UNITED STATES PATENT AND TRADEMARK OFFICE

APPLICATION NO.	FILING DATE	FIRST NAMED INVENTOR	ATTORNEY DOCKET NO.	CONFIRMATION NO.
10/781,138	02/18/2004	Kevin Corcoran	ORM / 242US	3385
26875	7590	09/06/2006	EXAMINER	
WOOD, HERRON & EVANS, LLP 2700 CAREW TOWER 441 VINE STREET CINCINNATI, OH 45202				PICKETT, JOHN G
ART UNIT		PAPER NUMBER		
		3728

Office Action Summary	Application No.	Applicant(s)
	10/781,138	CORCORAN ET AL.
	Examiner Gregory Pickett	Art Unit 3728

DETAILED ACTION

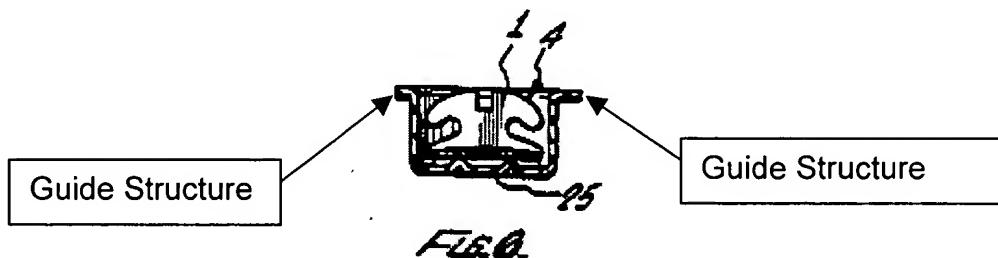
Insofar as the tray is not positively recited as structure, James discloses an orthodontic appliance package (see Figure 2), with a carrier **10** having a plurality of appliance constraining elements **11-17** therein, the constraining elements being cavities (see Figures 3 & 6) with surfaces **25** shaped to hold an orthodontic appliance as claimed (see for example, Figure 6), each constraining element having an orthodontic appliance **1** therein, and a guide structure (see below) that is fully capable of fixing the orientation of the package as claimed.

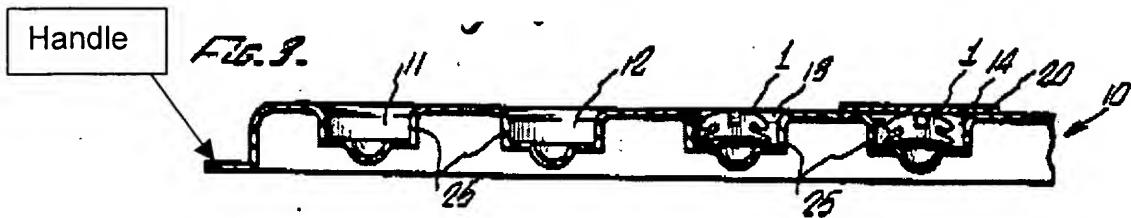
Leigh discloses a compartmented base **12** movably attached to a tray **11** for storing instruments in an organized and accessible manner (see Abstract). Leigh teaches a variety of compartment shapes, a number of which would be fully capable of retaining unspecified set-up trays. It would have been obvious to one of ordinary skill in the art at the time the invention was made to provide the tray of Brown with a compartmented base as taught by Leigh in order to store instruments in an organized and accessible manner.
